TOWNSHIP OF WELLINGTON NORTH

TO: Mayor and Council
DATE: 2024-09-23
MEETING TYPE: Open
SUBMITTED BY: Tammy Stevenson, Senior Project Manager
REPORT #: INF 2024-016
REPORT TITLE: Fergus Street North Reconstruction Update

Memo

Re: Fergus Street Reconstruction Design Update

TOWNSHIP OF WELLINGTON NORTH
FERGUS STREET RECONSTRUCTION
 Plan View from Sligo Road to Sta. 0+780

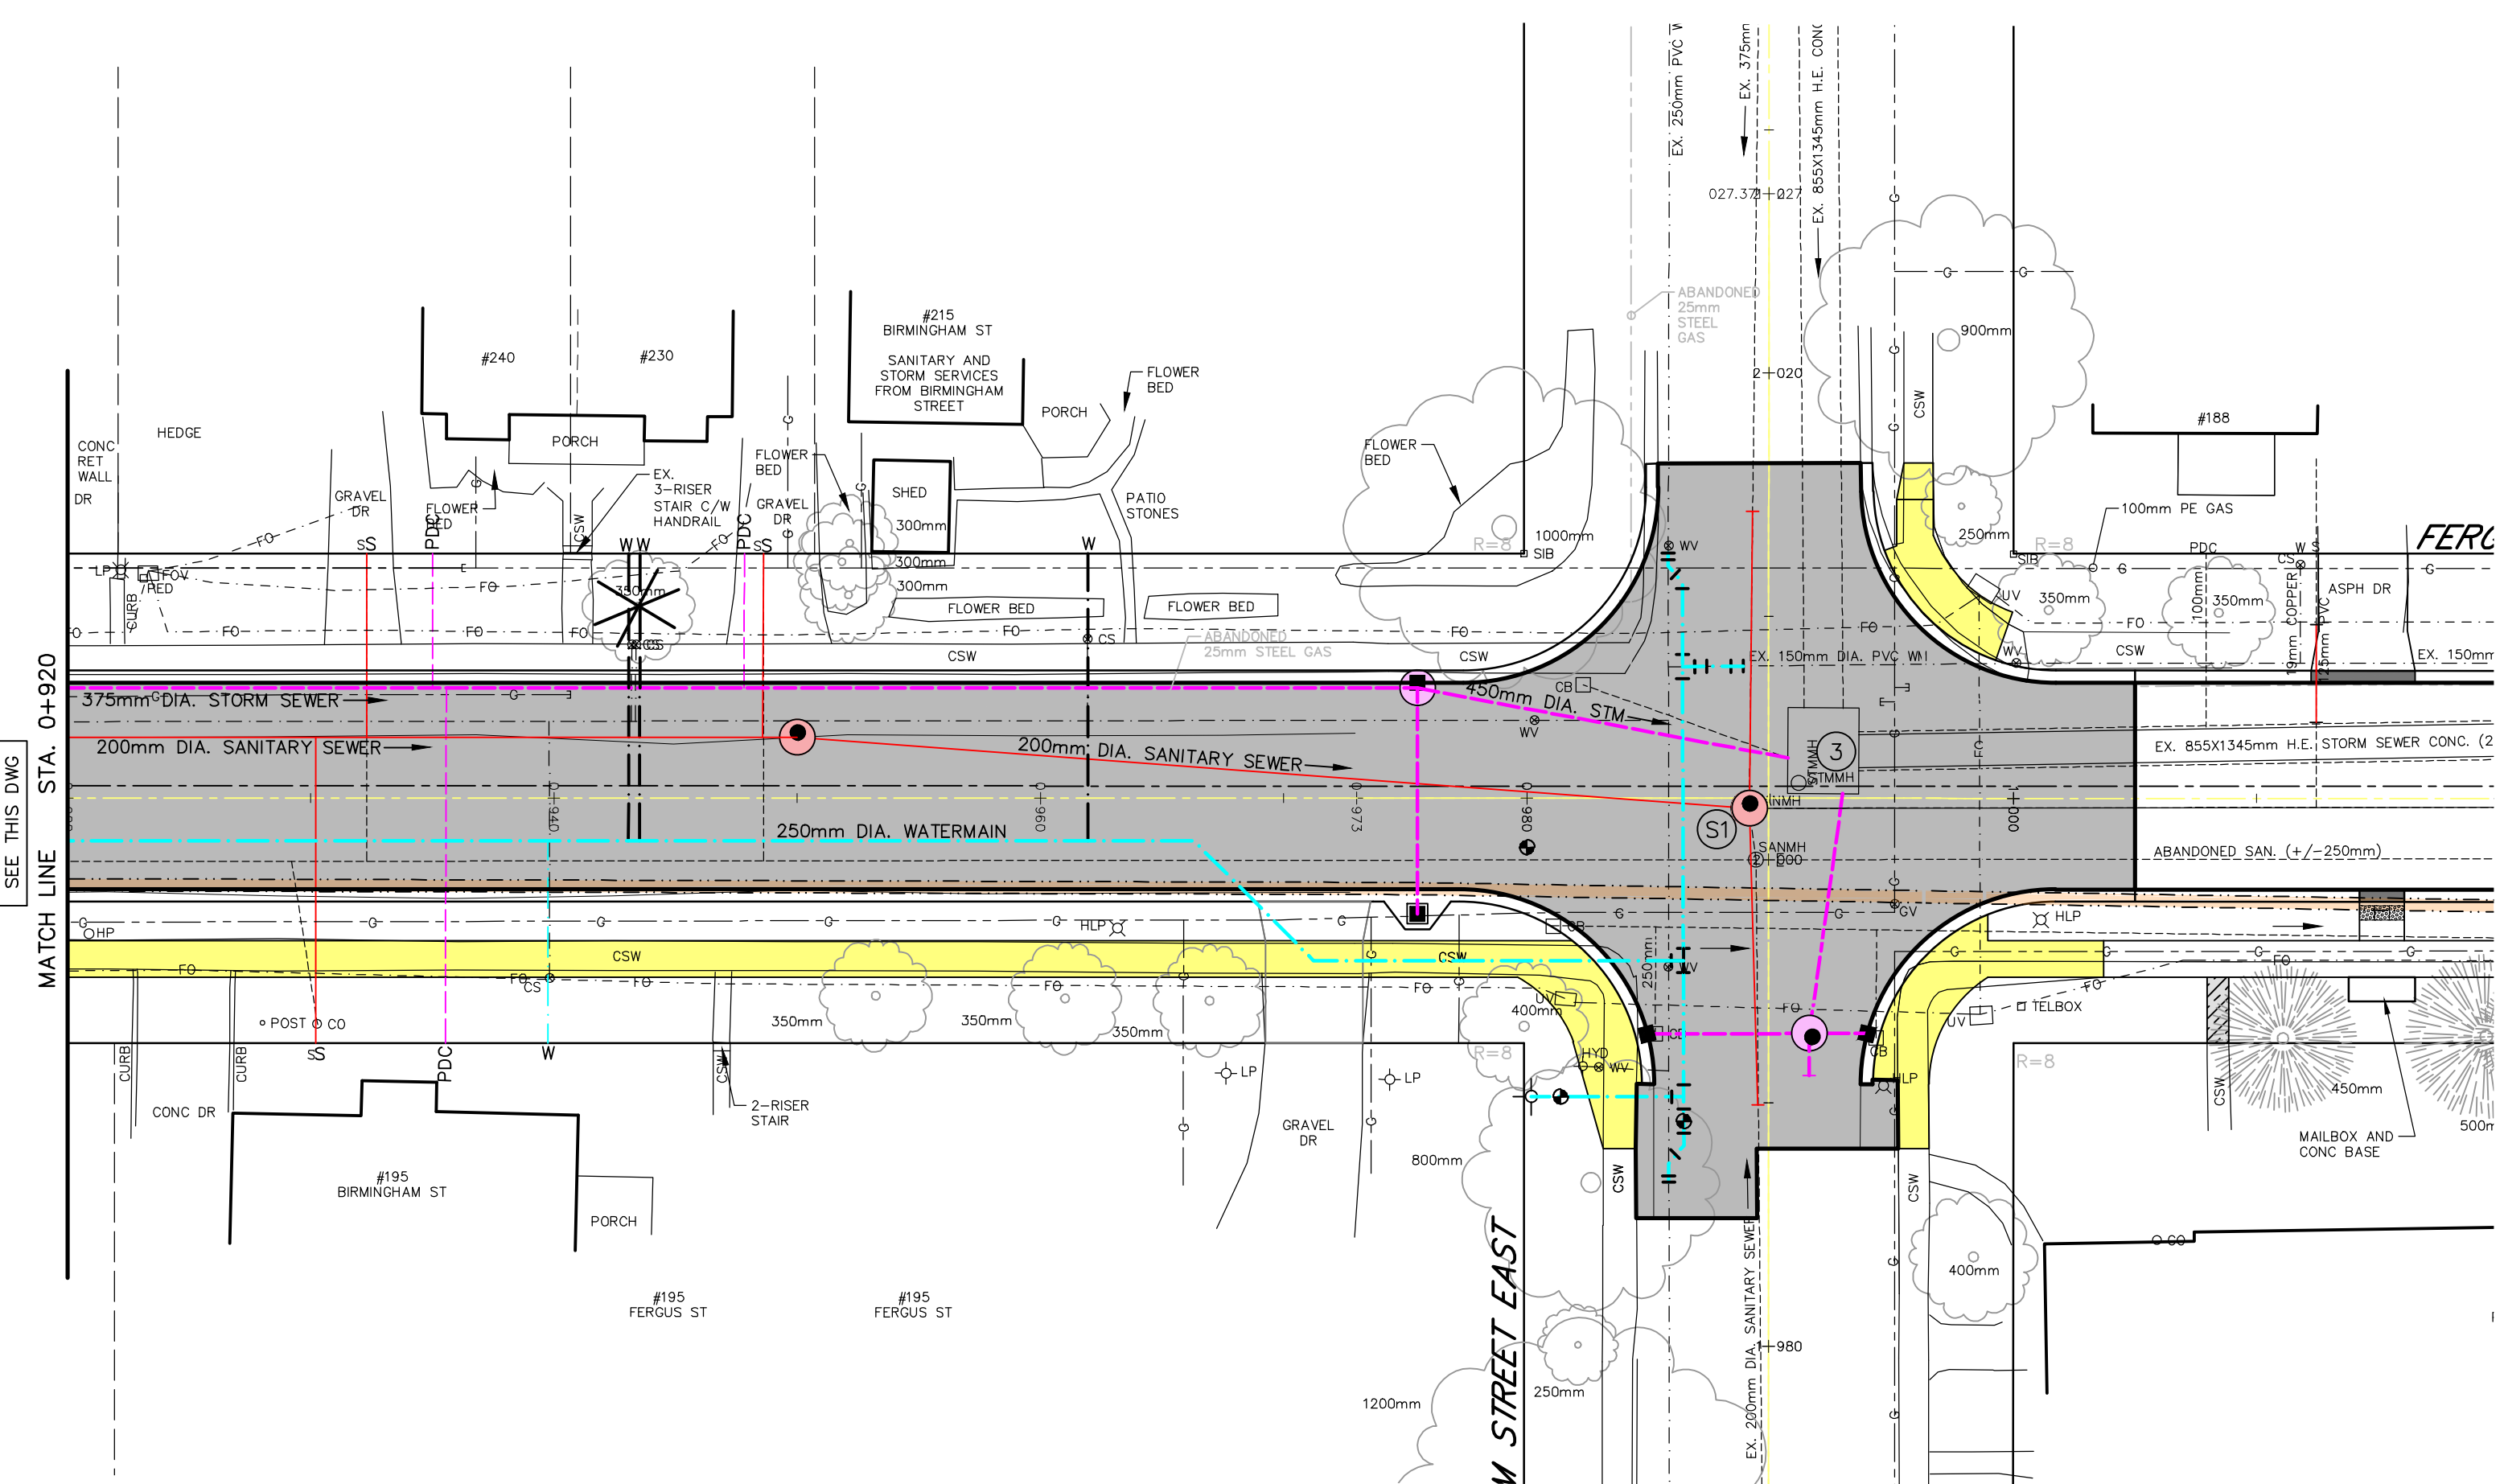
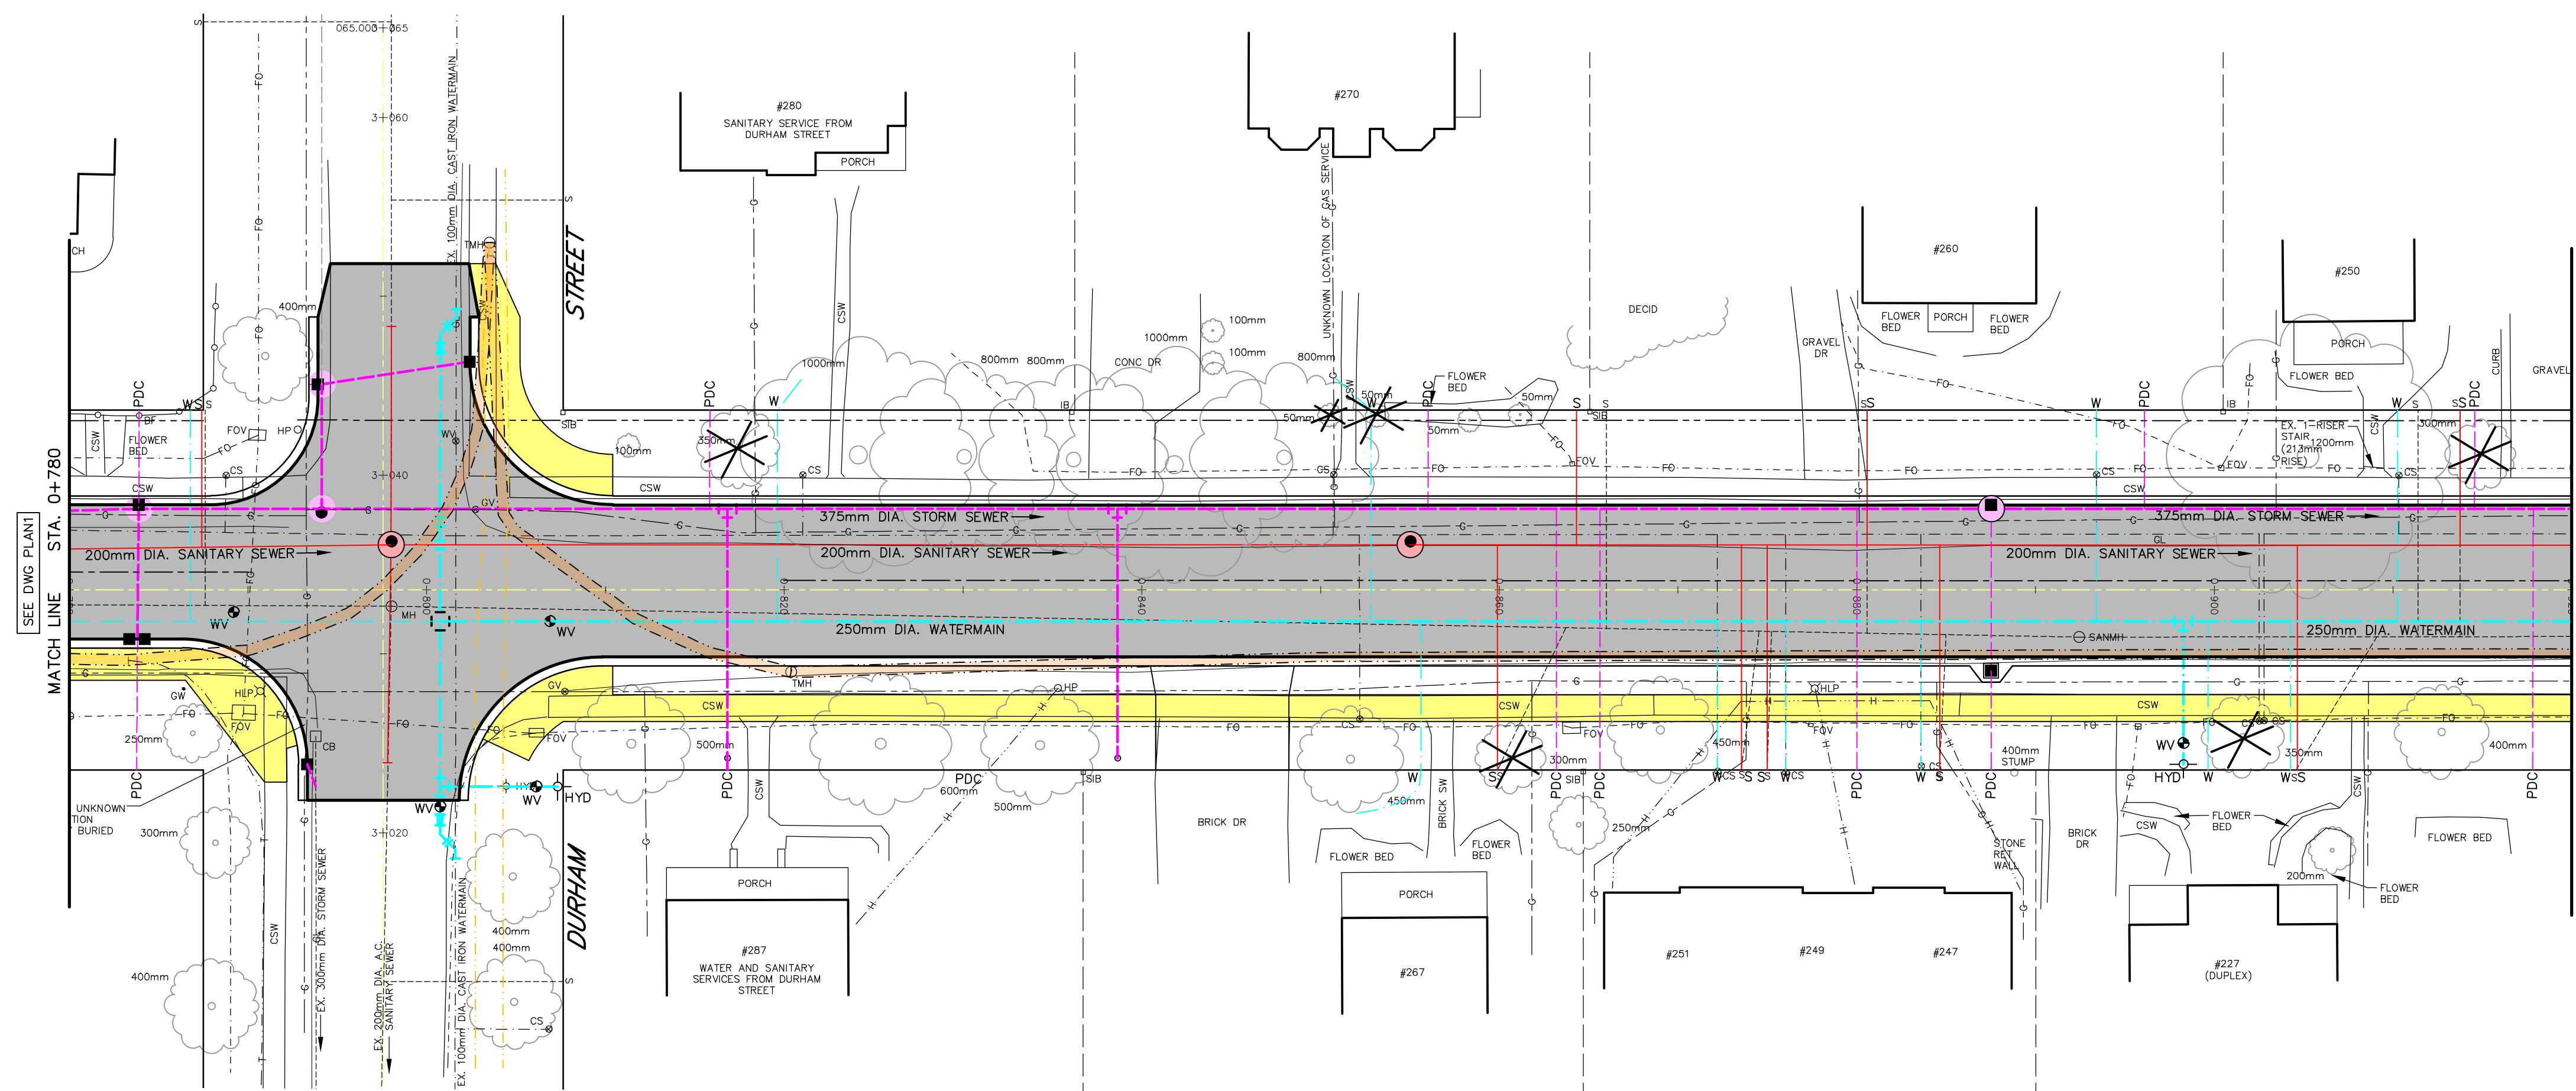
The approach noted in the first two bullet points above was successfully implemented for the Wellington-Birmingham block, and the reconstruction of this block was recently completed and did not include any tree removals. A preliminary drawing set of the current design for the northern two (2) blocks (Birmingham to Sligo) is included in Appendix B. The anticipated conflicts for the northern two blocks are described in the following section.

- For all three blocks, the proposed sidewalk was switched to the west side of the road. This avoided conflicts with several large (1000mm+ trunk) trees along the Durham-Sligo block.
- For all three blocks, a non-standard design approach for servicing was implemented wherein service piping was permitted to be deflected on the private side of the right-of-way (ROW) within acceptable limits.
- For the Durham-Sligo block, the proposed road width was reduced to 7.5m from the standard 8.5m. As a result, parking on the east side of the road for this block will need to be prohibited.
- For a portion of the Durham-Sligo block, the running line of the proposed storm sewer was shifted to the west from the previous design to minimize damage to tree roots during installation.

SERVICING APPROACH

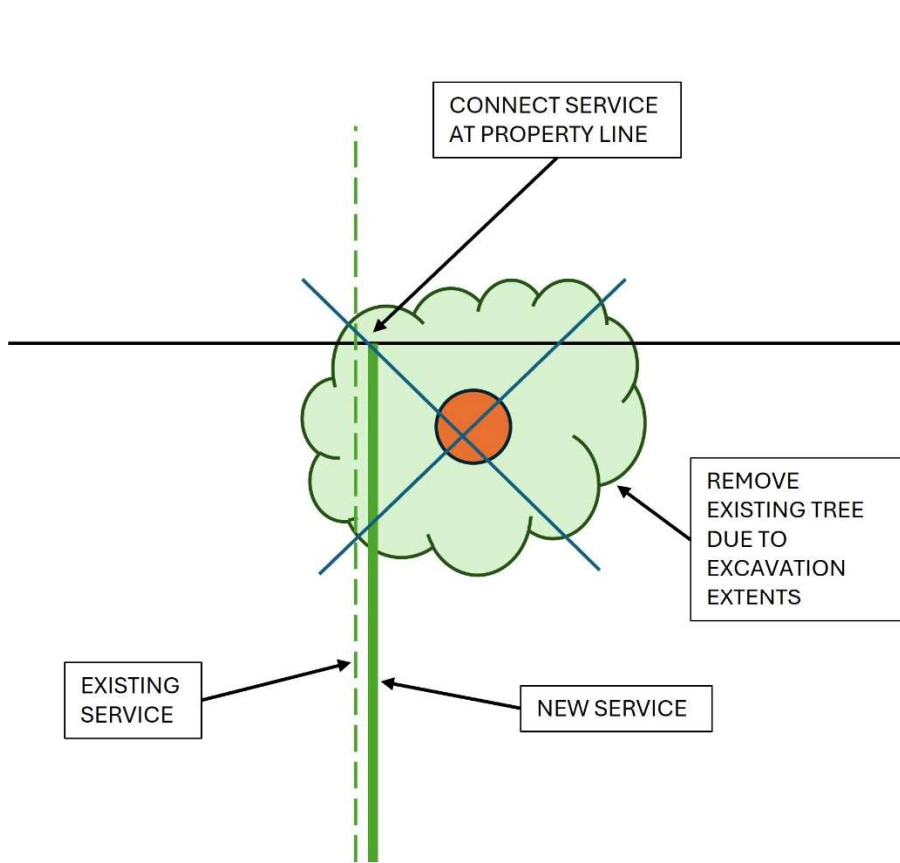
- The revised design results in more-than-typical excavation, pipe work and restoration required on private property which will increase costs. Typically in reconstruction projects the work may just encroach onto private property in order to reconnect a service or to re-grade a driveway. However, since the services

are to be routed around the trees, this will necessarily entail additional excavation and restoration that wouldn't normally be required. An illustration of this is shown in Appendix C.
